EROSION AND SEDIMENTATION STUDY REPORT

R.L. HARRIS HYDROELECTRIC PROJECT

FERC No. 2628

STAKEHOLDER COMMENT TABLE

FIGURE 3-1 TALLAPOOSA IMPAIRED STREAMBANK CONDITION AREAS

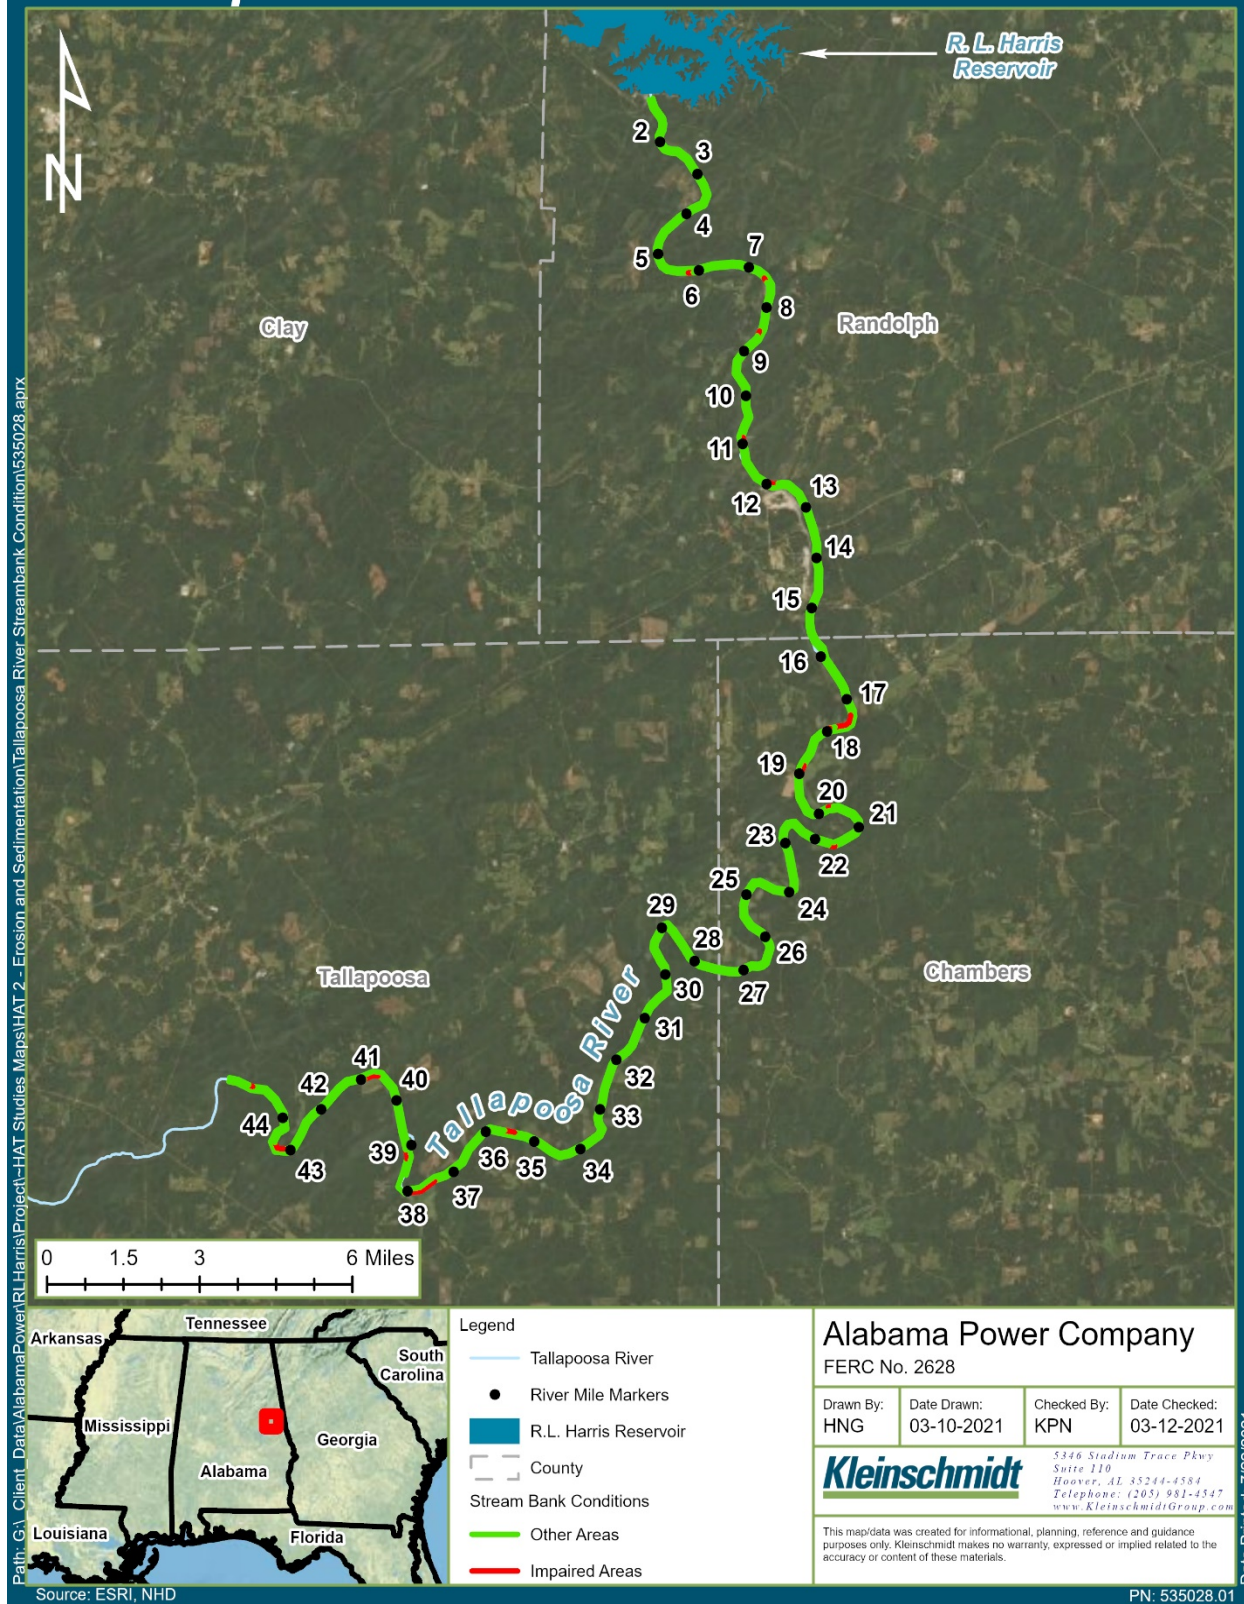
Commenting Entity	Date of Comment & FERC Accession Number	Comment – Erosion and Sedimentation	Alabama Power Response
		<p>Table 2-1 Summary of Lake Harris Erosion & Sedimentation)</p> <p>Request for long/data for Figure 3-1 and Table 3-2 of the Trutta Report and Request greater resolution image of Figure 3-1</p> <p>Of major concern to all Harris Project Stakeholders is the Erosion Issue. Foundational to taking steps going forward is looking back to what has been. The University of Alabama maintains an aerial photographic library including images of the Harris Project area beginning in 1942. In existence are digitized prints for 1942, 1950, 1954, 1964, 1973. These are housed at www.alabamamaps.ua.edu. Attached is a mosaic of a portion of the project area as it appeared in 1942. The full sized map is rendered and georeferenced.</p>	
<p>Donna Matthews (only the portion of the letter that to this study has been included in this table)</p>		<p>#2 Proposed: A New Study of the downstream river using historic images overlaid onto current imagery</p> <p>18 CFR 5.15 (e)</p> <ol style="list-style-type: none"> 1. Erosion is a significant and persistent concern. Erosion is problematic for landowners and flora & fauna in and around the river. 2. To my knowledge, this type of GIS comparison using historic data to impact effects of release effects downriver have not been done. 3. At the initial licensing there was no post dam data to compare to compare to the historic data. 4. This is a simple and inexpensive study, using readily available data <p>18 CFR 5.0(b)</p> <ol style="list-style-type: none"> 1. The study should look at and provide change analysis for: <ol style="list-style-type: none"> a. Analysis of the river bank contour along its length through time. Free flowing rivers are elastic, moving silt and sedimentation from side to side and down its length. A river serving as a channel should show deviations from historic patterns. b. Any changes in river bank elevation 	<p>Alabama Power provided a response to this additional study request in its July 10, 2020 Response to Initial Study Report (ISR) Disputes or Requests for Modifications of Study Plan (Accession No. 20200710-5122).</p> <p>Alabama Power filed the images provided by Ms. Matthews with FERC on August 4, 2020 (Accession No. 20200804-5252)</p>

Figure 20: Right Bank Modification Score for the upper Tallapoosa River HDSS project.

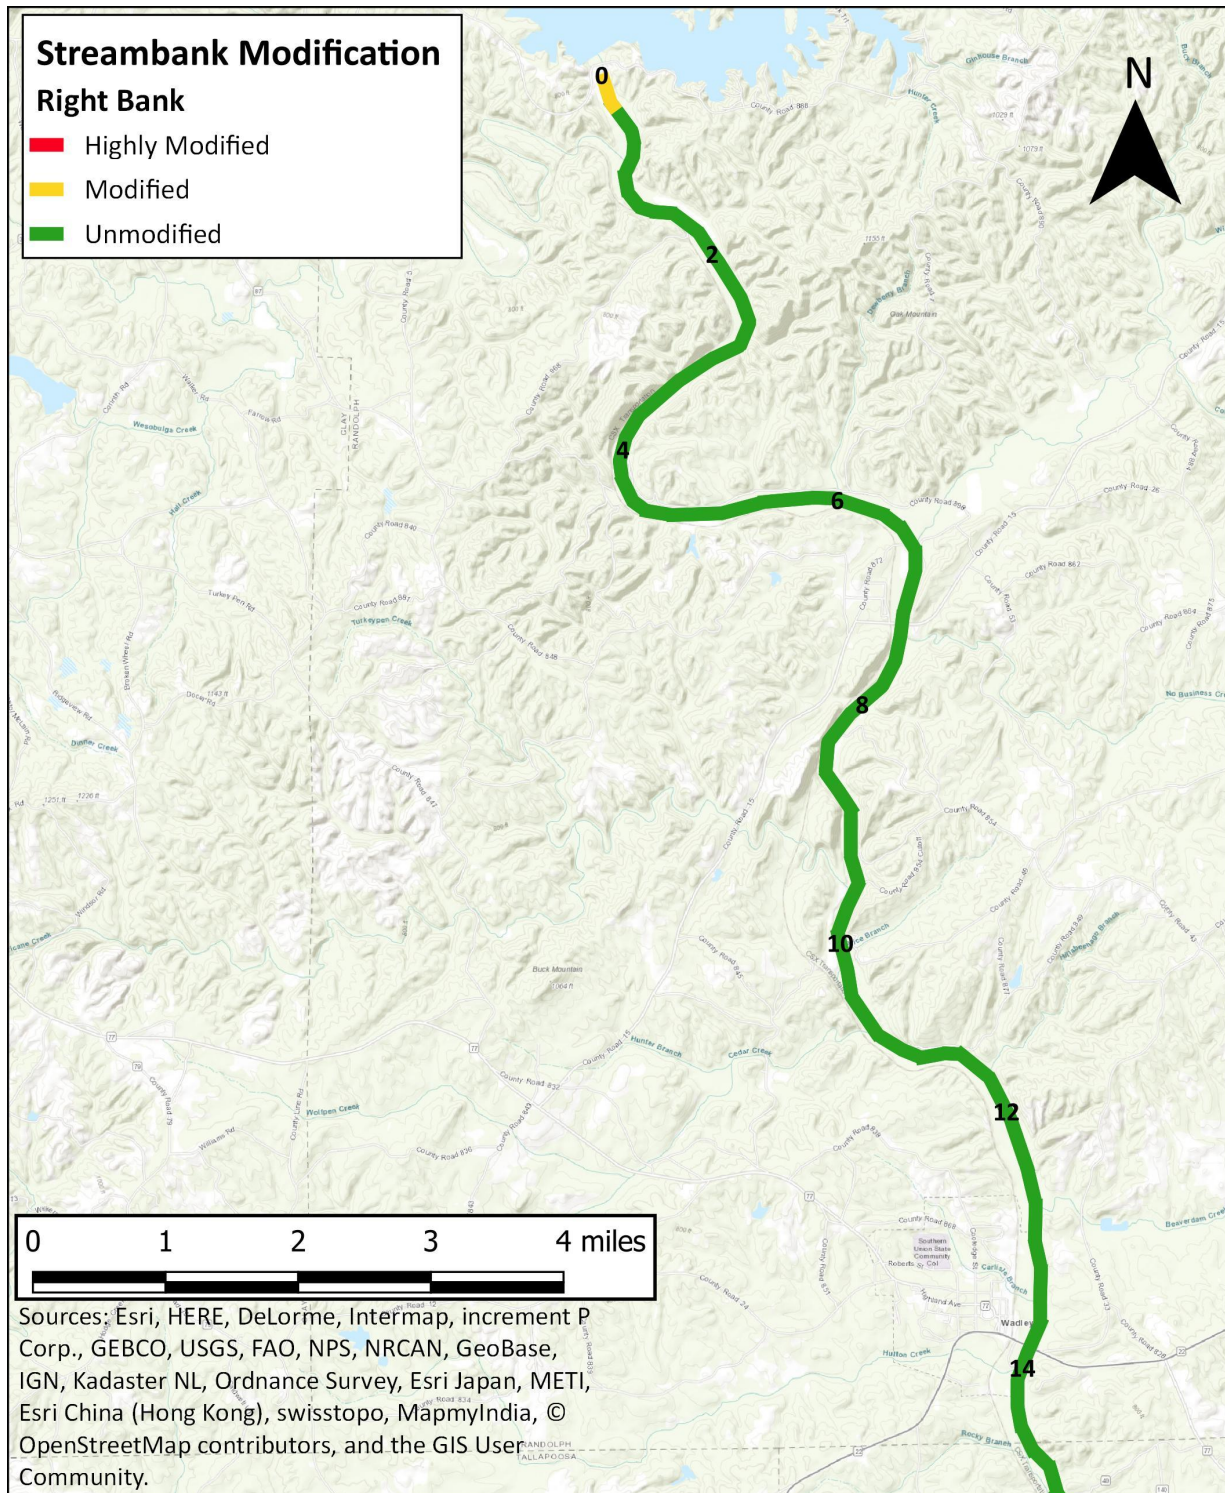
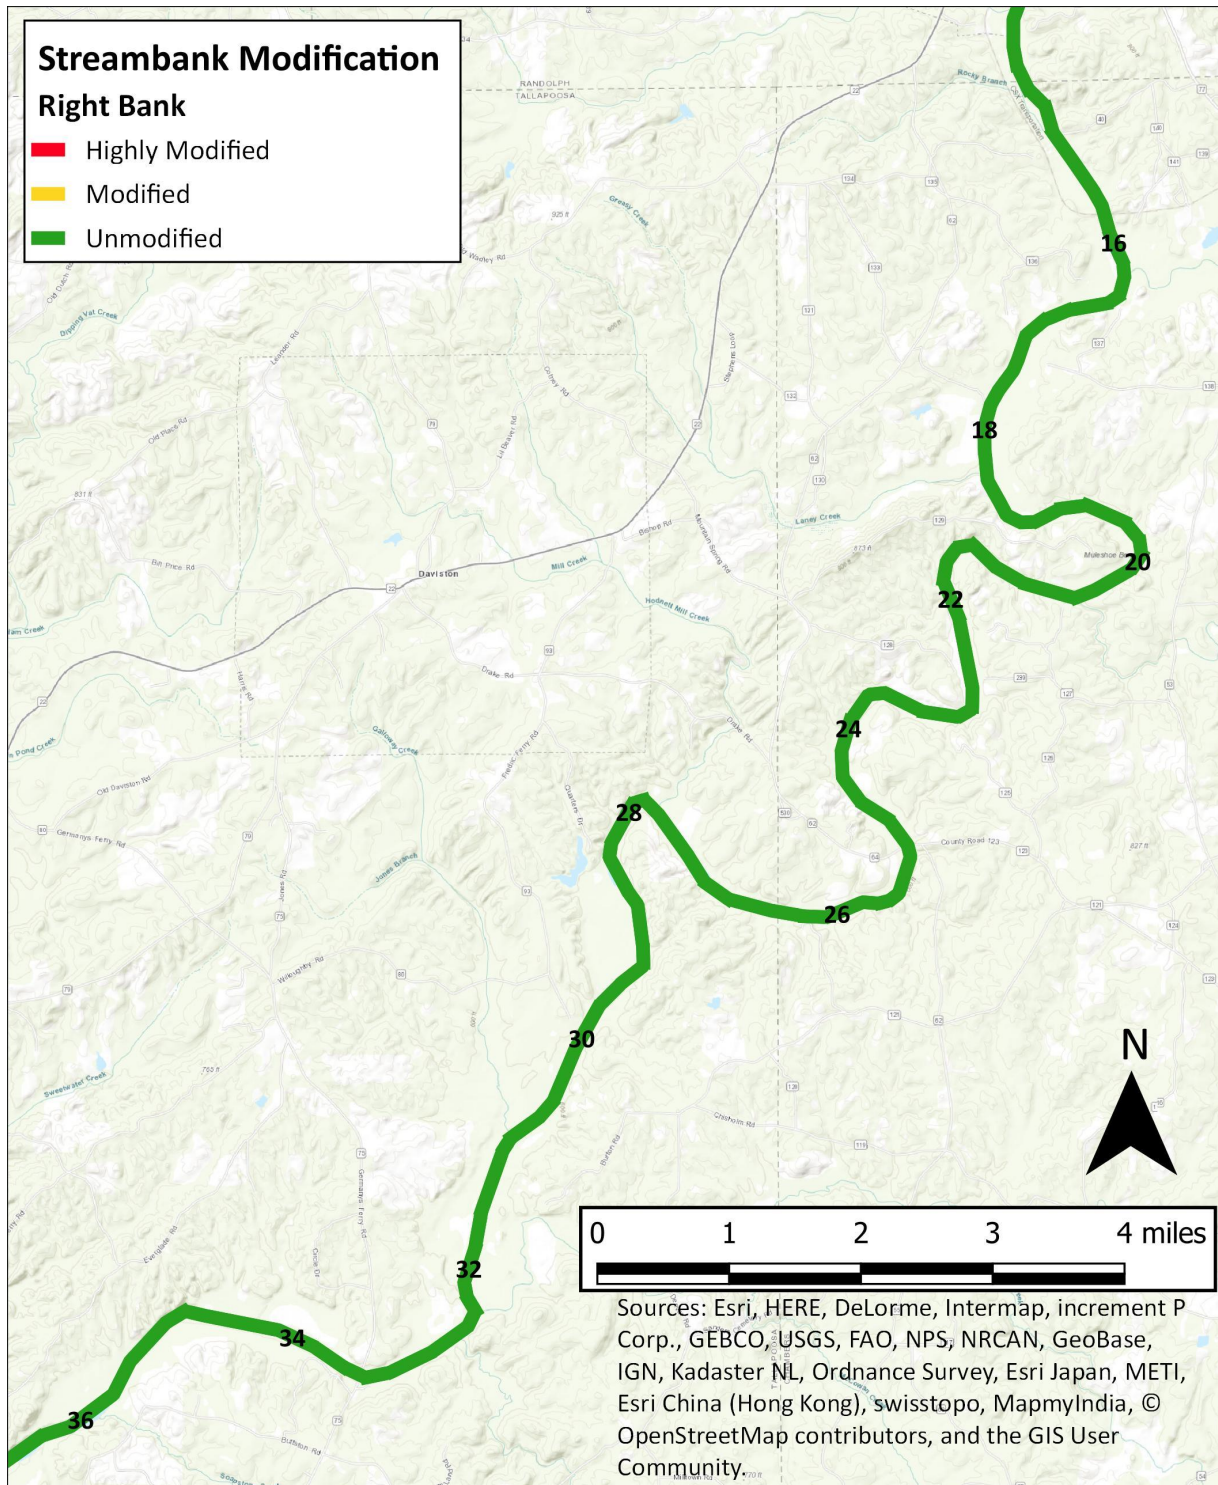
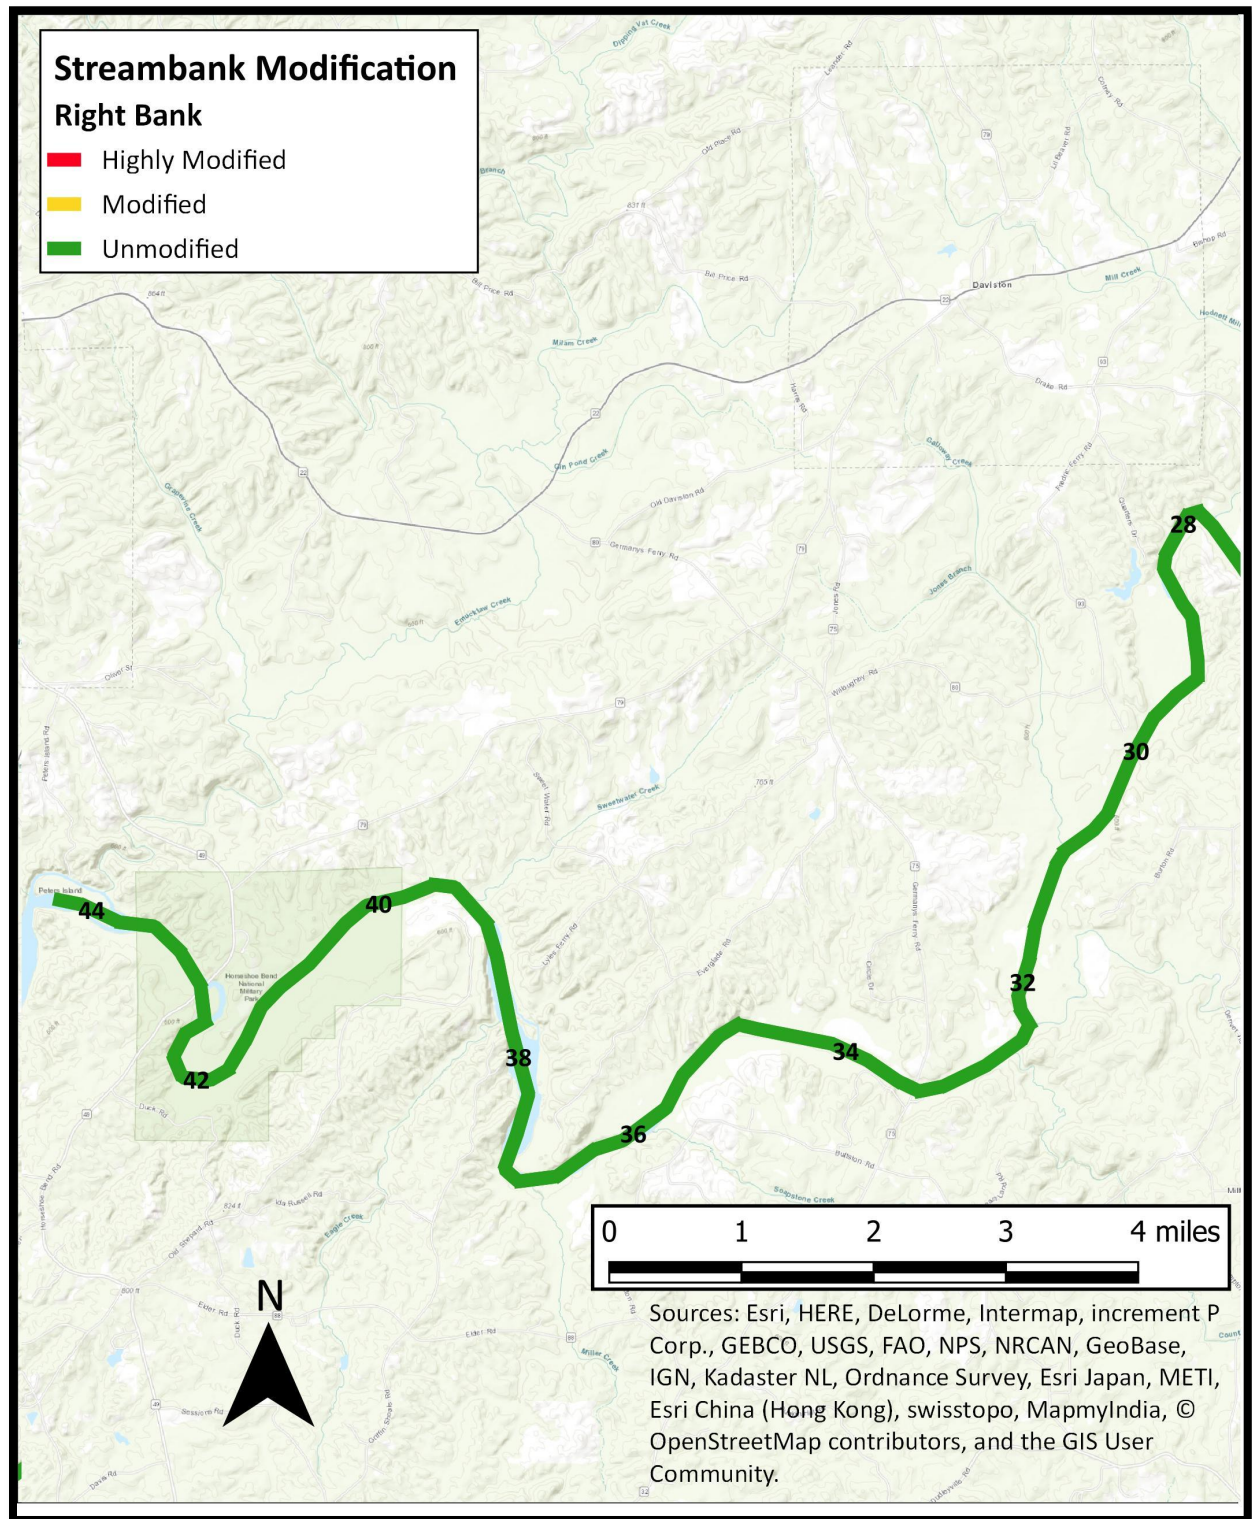
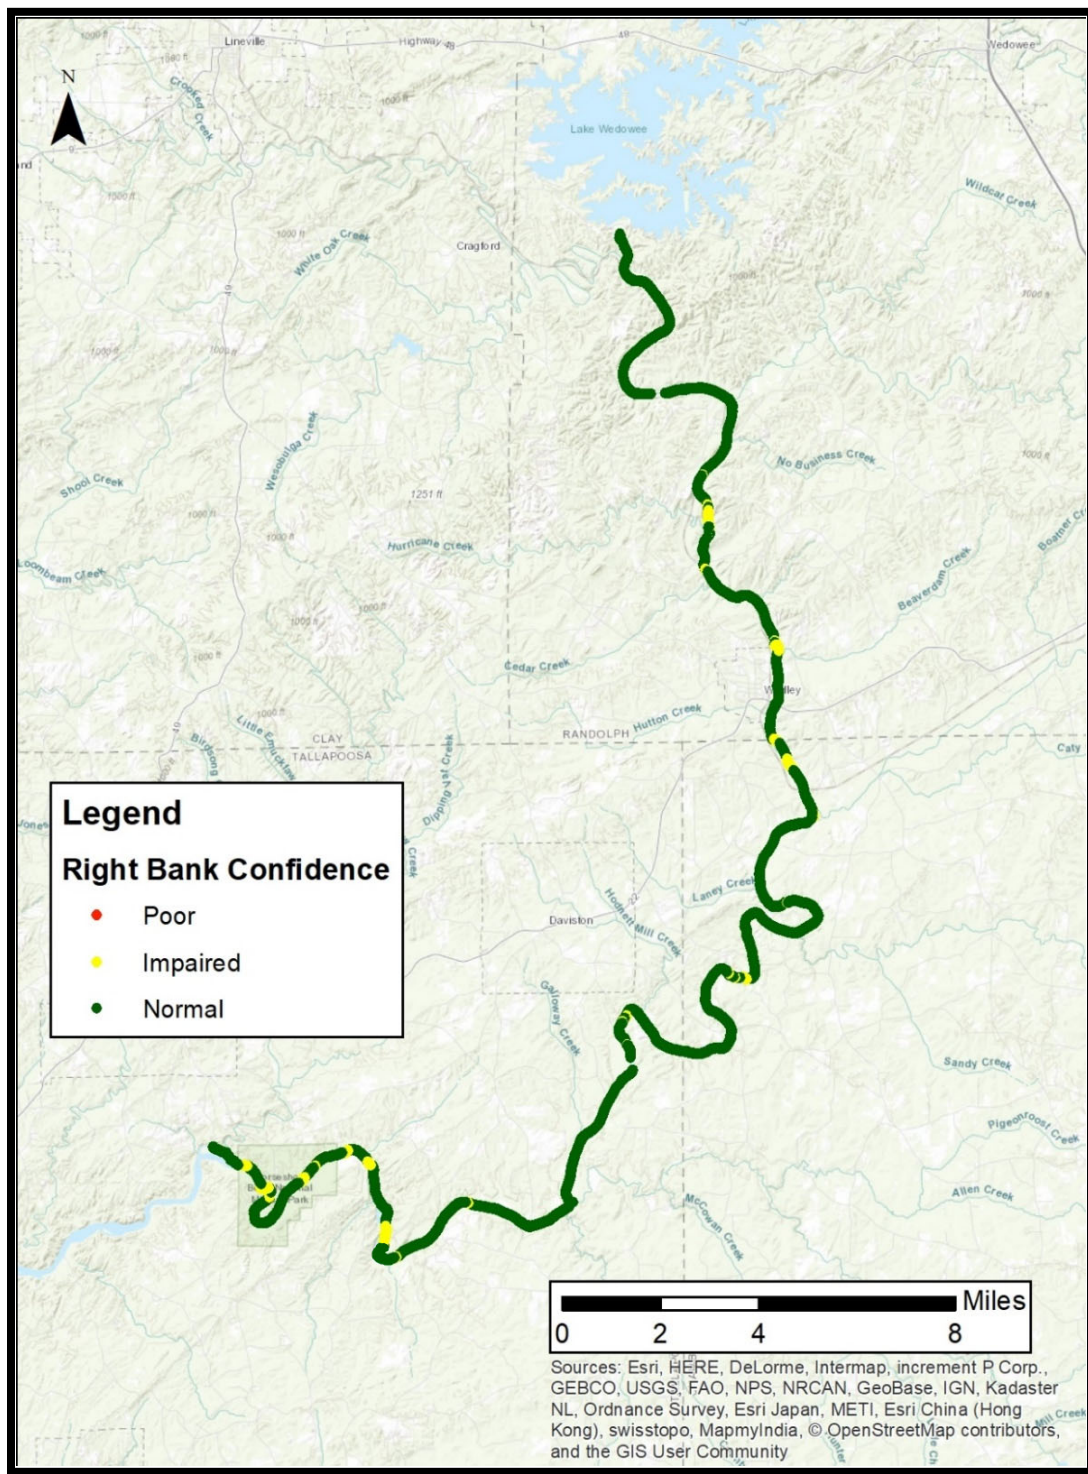
Commenting Entity	Date of Comment & FERC Accession Number	Comment – Erosion and Sedimentation	Alabama Power Response
	Questions submitted in advance of 4/28/20 ISR Meeting	<p>For Figures 20 through 23 of the Tallapoosa River High Definition Stream Survey Final Report, please label the river mile ranges on the maps to help reviewers understand the starting and ending points of the study area and which segments of river are included.</p> <p>In Figure 26 of the Tallapoosa River High Definition Stream Survey Final Report, please move the scale bar and sources so that they are not covering the river segment and bank conditions at the bottom of the map</p>	Revised figures are provided in the Tallapoosa River High Definition Stream Survey Final Report (updated December 17, 2020).
	Questions submitted in advance of 4/28/20 ISR Meeting	Can you identify where peaking pulses are attenuated downstream from Harris Dam under the current operating regime and volume of typical downstream releases? If so, are there any patterns in the downstream streambank conditions and observed levels of erosion along the segments of streambanks within the attenuation zone? Where are the identified erosion sites in relation to the length of the attenuation zone?	Included in Section 3.2 of the Final Erosion and Sedimentation Study Report.
